## Product lifespan / usage advice

### ALTIRANDO 3

### EVOLITE

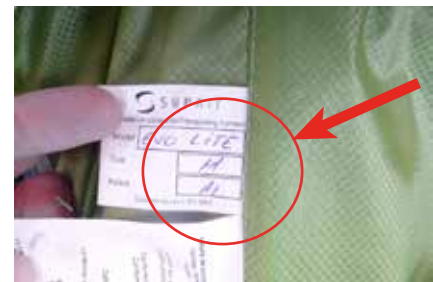
The fiberglass batten located beneath the seat may, in some instances, pierce the fabric.

The batten was placed inside its sleeve without protection, thus exposing one end with sharp edges.

Version C1.1 has been modified and does not pose a problem anymore.

**Remove the batten :**

**Depending on the pilot's size, the batten may or not be useful.**  
 Conduct a hang-test with and without the batten in place.

Contact us at [sav@supair.com](mailto:sav@supair.com) to receive a batten with two protective end caps corresponding to your harness model and size.
